Q222880801-LTR-V0001-00

Subject Proposed Landfarm – Kugaaruk

This is in response to your correspondence, dated May 10, 2006, to Mr. Navjit Sidhu regarding the review of the Water Licence Application submitted by Wardrop Engineering for a soil treatment landfarm near the Hamlet of Kugaaruk. Mr. Sidhu has directed Wardrop to provide responses to the issues raised in your letter.

DESIGNED BY: LS	DRAWN BY: SR	DWG NO.
CHECKED BY:	DATE: 06.05.31	0222880801-SKT-M0001-A

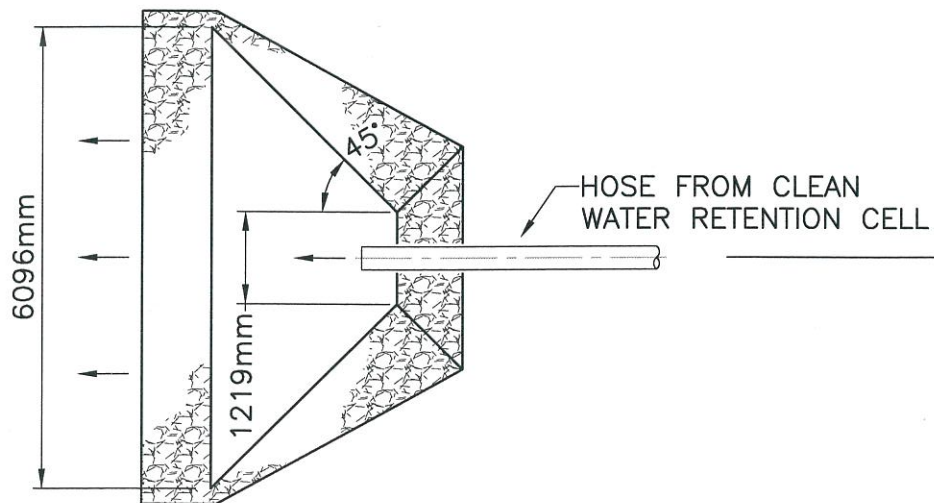
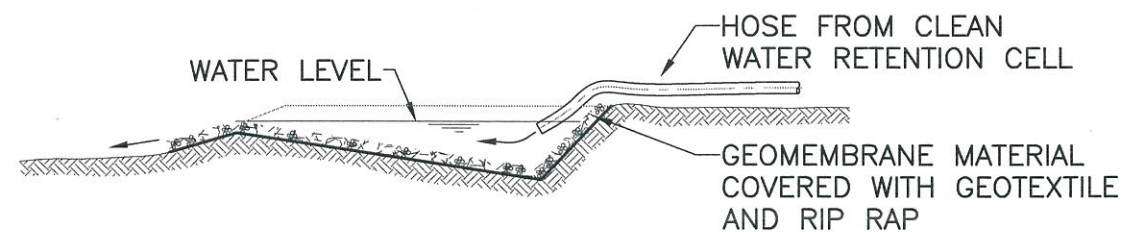
1. Splash Pad and Discharge Route

The most likely location for the splash pad will be to the west of the retention cell. The design of the pad and an approximated dispersal path from that point is illustrated on sketch SKT-M0001-A (attached).

The exact location of the splash pad will be determined in the field since topographic drawings do not necessarily reveal the required level of local detail. The intent will be to use a location where downstream flow can dissipate over a relatively broad area via existing natural drainage contours, instead of promoting channelized flow.

The splash pad will be constructed of two layers of nonwoven geotextile covering an area of approximately 50 m². The geotextile will be covered with riprap to a depth of 250 mm. Riprap will consist of local rock sized from 20 to 150 mm. The base will be cleared of debris and compacted with local equipment before placement of the geotextile. The configuration of the pad will broaden toward the downstream end to promote wider distribution of the discharge. During discharge periods, the line from the pump will be fixed at the upstream side of the splash pad. The discharge will be visually monitored on a frequent basis. The location of the discharge line will be adjusted as necessary to optimize the flow conditions over the pad and the riprap blanket will be repaired as necessary by adjusting the configuration of the stone layer.
